Access Compliance Report Public Rights-of-Way (Curb Ramps)

Intersection ID: 9841	Main Street: N_GRAHAM_ST	Cross Street: WOODWARD_AV	Location: SW
ADA ID: 25C7983190D7	Ramp Type: ParaDiag	Initial Pass/Fail: Fail	Overall Compliance: No Severity Score: 8.75

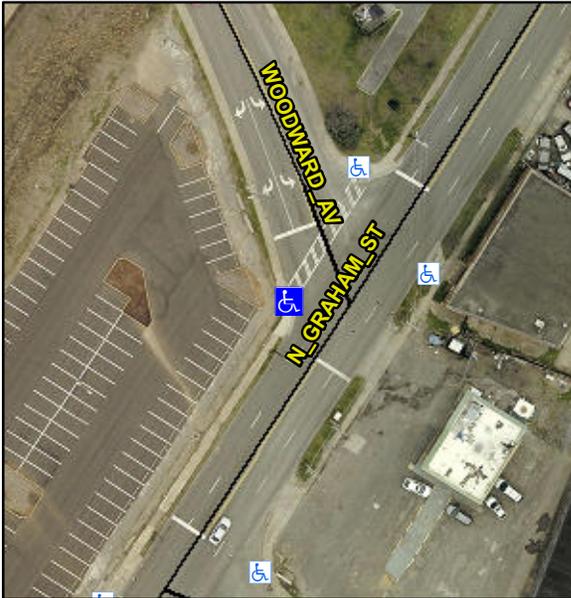
LT RP < 5%

R304.5.1

Remove & Replace Curb Ramp With Two New Directional Ramps or Equivalent.
